IEEE802.3bt  
LLDP adhoc

Meeting #4: Wednesday July 5, 2017

# LLDP concept review as agreed in D2.5 – Updated per the current text Proposal for a change marked in RED. Agreed concept marked in BLUE.

## Annex A: Why we need $Y=A+B$ as currently in the spec? -2

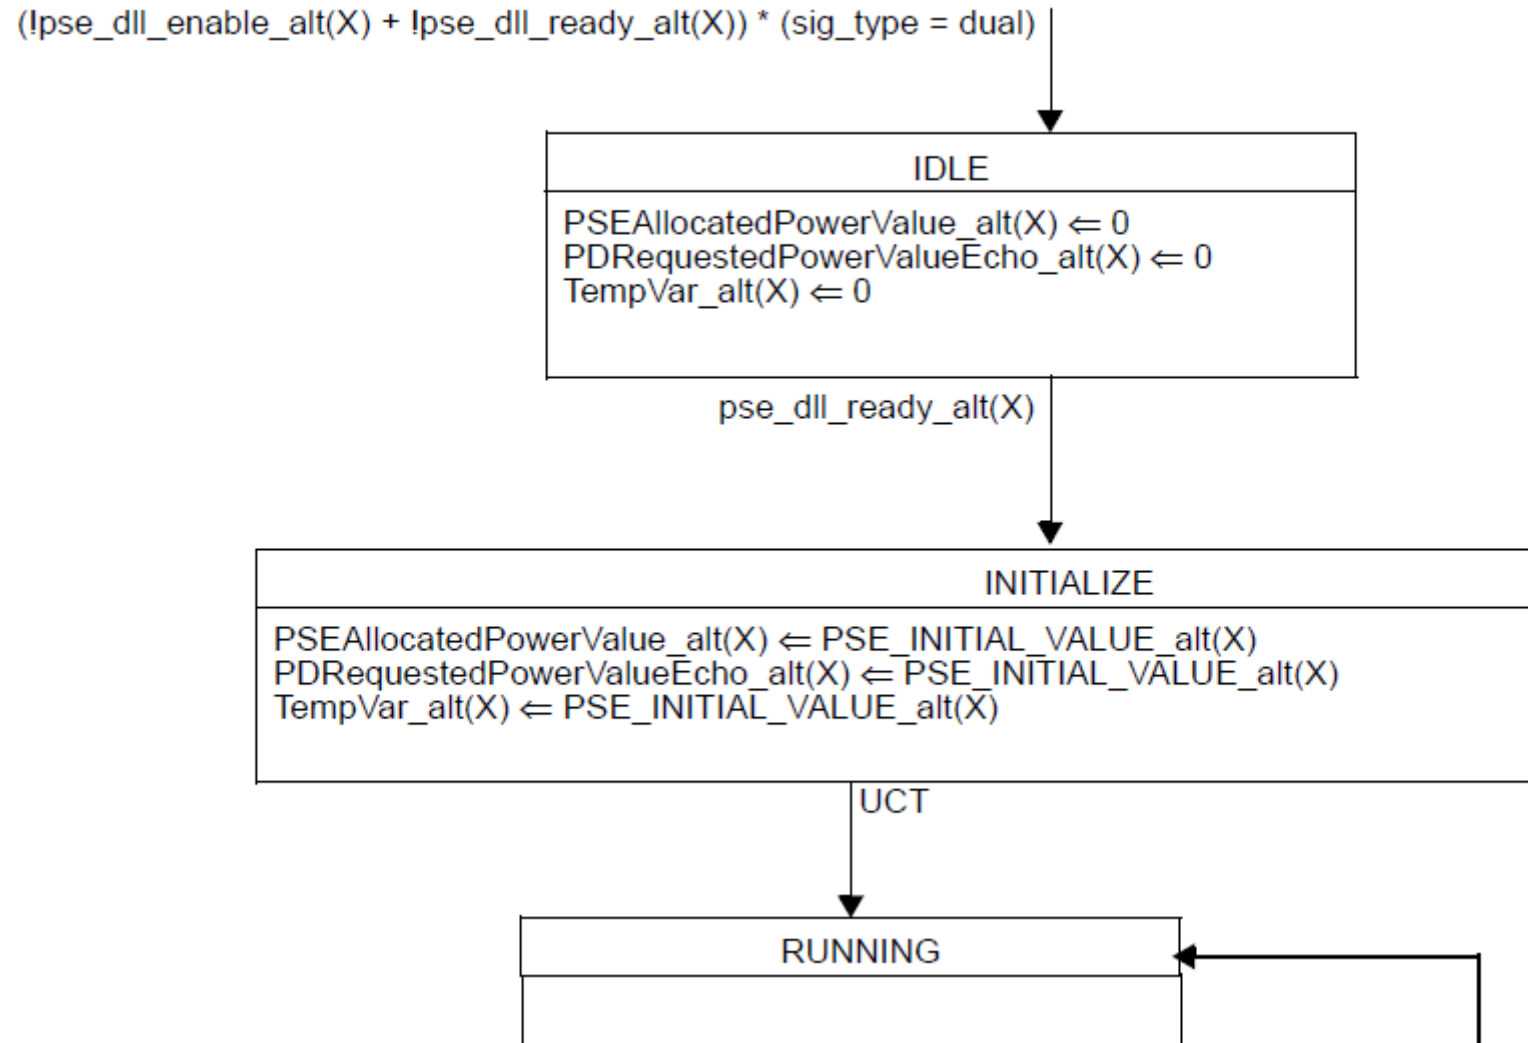
- Argument #3

High level power management care only for the total port power. The power management per pairset is kind of sublayer of the power management system. It is useful to pass the total power through the TLVs field. This is in general how current PSEs systems works.

Other alternative solution to this problem is to use the field “PSE max available power” which should be the total port power. We need to clarify in 79.3.2.6e that this value is applicable for PSE that supports single-signature and dual-signature.

## Annex B: Comment #297 D2.4 (Page 75 line 12 in D2.5) - Figure 145-43

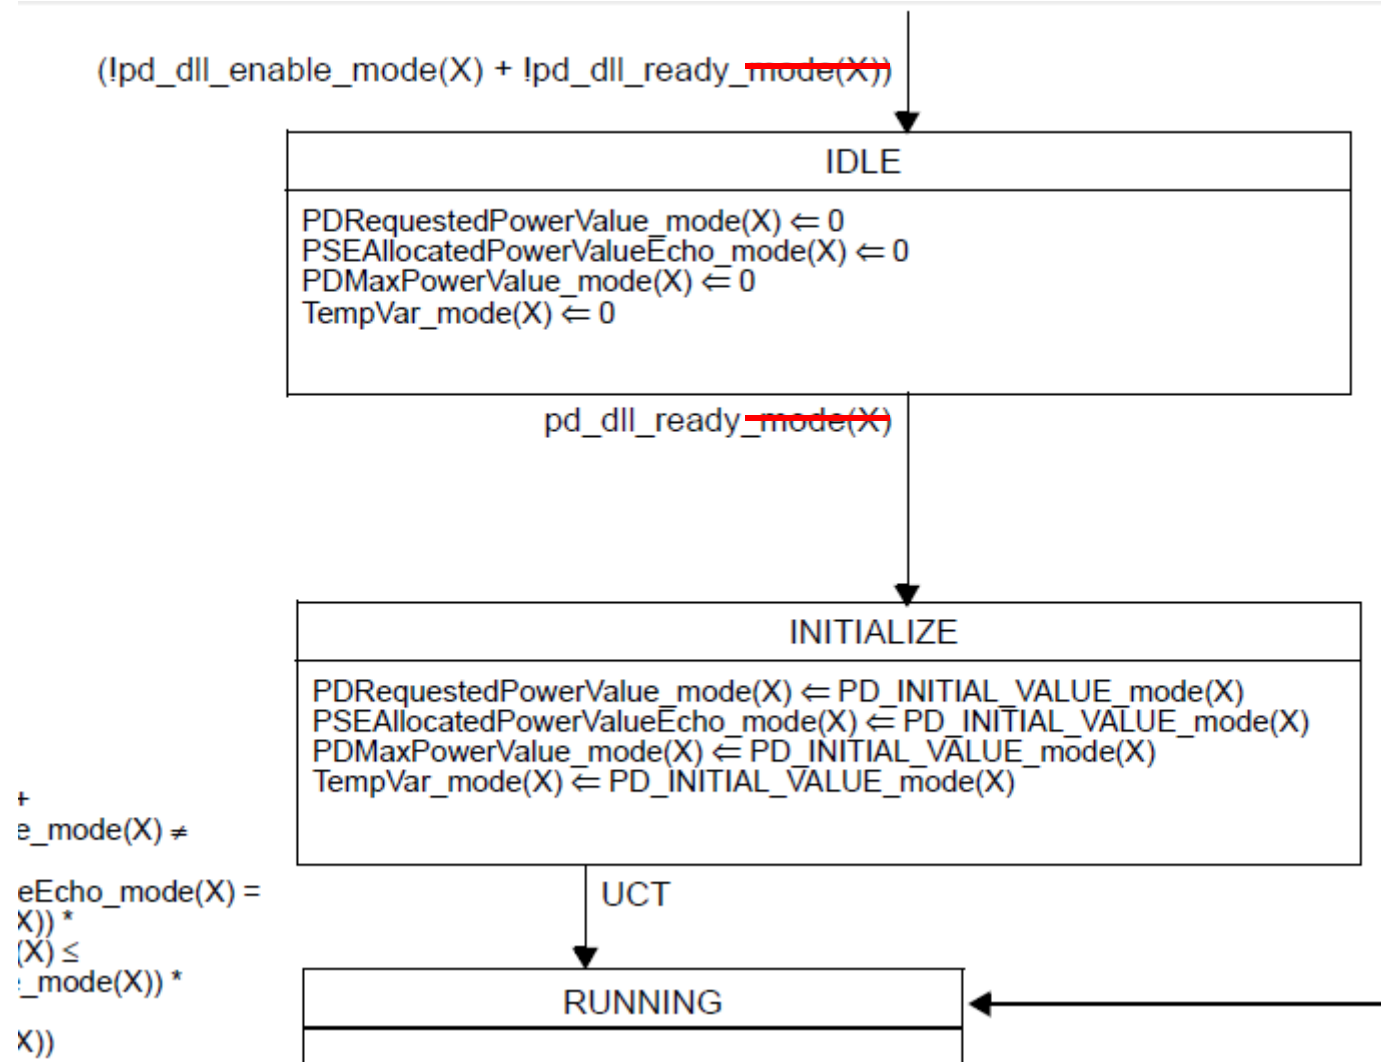
- We have the information of total available power in the field “PSE maximum available power” in 79.3.2.6e. This resolve argument #2 in Annex A.
- To resolve #297, Lennart suggests: In order to request power on the unpowered pairset, see proposed changes in the red text. In addition, the `pd_dll_ready_mode(X)` need to be changed to `pd_dll_ready` to allow progressing to the INITIALIZE state in case PD want power on the unpowered pairset. No changes required in the PSE portion.

- Comment #297 D2.4 (D2.5 Page 78 line 46)

"If Mode (X) is non-active while the other mode is active, the inactive PD requested power value Mode (X) field value shall be set to 0."

- What is this trying to do ? The PD may wish to ask for power on an unpowered Mode...

Strike sentence.

- In Figure 145-44 and Figure 145-45 power control state diagrams when connected to dual-signature PD, we add in D2.3 an IDLE state in order to resolve non active Alternative(X) or no active mode(X) by setting the relevant variables to zero prior going to INITIALIZE state.
  - Figure 145-45: PSEAllocatedPowerValue\_alt(X), PDRequestedPowerValueEcho\_alt(X) and TempVar\_alt(X)
  - Figure 145-46: PDRequestedPowerValue\_mode(X), PSEAllocatedPowerValueEcho\_mode(X), PDMaxPowerValue\_mode(X) and TempVar\_mode(X)

- Yair it will work:
- The proposal is:
  - To change from `pd_dll_ready_mode(X)` to `pd_dll_ready` in the PD state machine.
  - To change “if this mode/Alt is inactive, set to value 0” to “if this Alt is inactive, set to value 0” i.e. keep this requirement only to PSE.

- Group is OK.

- Lennart response: The proposed response to this comment is to adopt:
  - To change from pd\_dll\_ready\_mode(X) to pd\_dll\_ready in the PD state machine.
  - To change “if this mode/Alt is inactive, set to value 0” to “if this Alt is inactive, set to value 0” i.e. keep this requirement only to PSE.
- **Group to discuss.**
- **GROUP OPINION? Group is OK.**
  - The modifications proposed to the state machine in Figure 145-43?
  - To change from pd\_dll\_ready\_mode(X) to pd\_dll\_ready in the PD state machine.
  - To change “if this mode/Alt is inactive, set to value 0” to “if this Alt is inactive, set to value 0” i.e. keep this requirement only to PSE.
